MODEL SC-3 RADAR TRANSMITTING EQUIPMENT

ELECTRICAL AND MECHANICAL TESTS

2-1. ABSTRACT

Model SC-3 Radar Equipment
 Variation Of Transmitter Pulse Width
 With
 Setting Of Output Matching And Output Coupling Controls

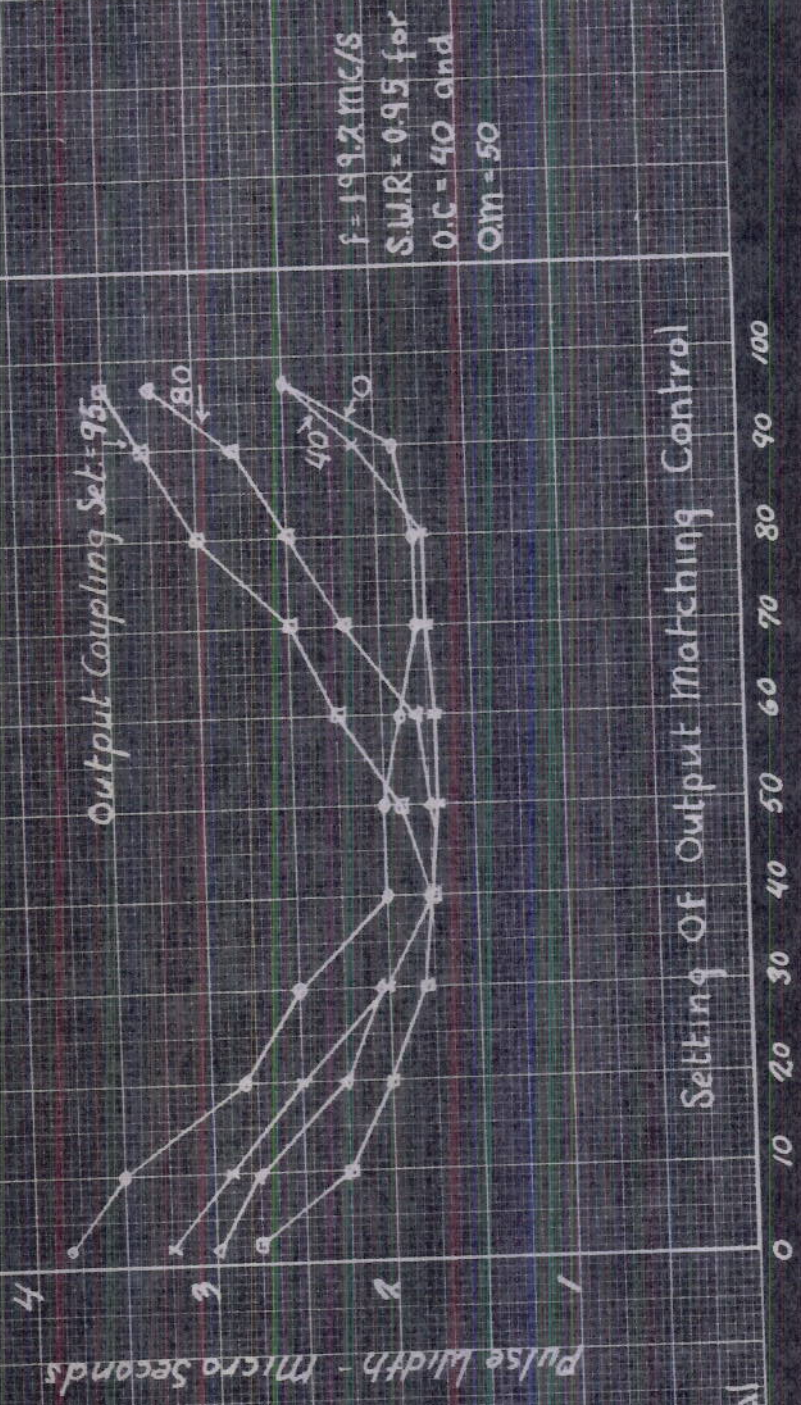
Plate 116 shows the manner in which the output pulse width varies with the setting of the "output matching" and the "output coupling" controls. It should be noted that because of certain limitations in the measuring equipment, all of the values shown for pulse lengths are too short by an estimated 1/2 microsecond. For example, where a pulse length is shown to be 1.5 microseconds according to the graph the true value is approximately 2 microseconds.
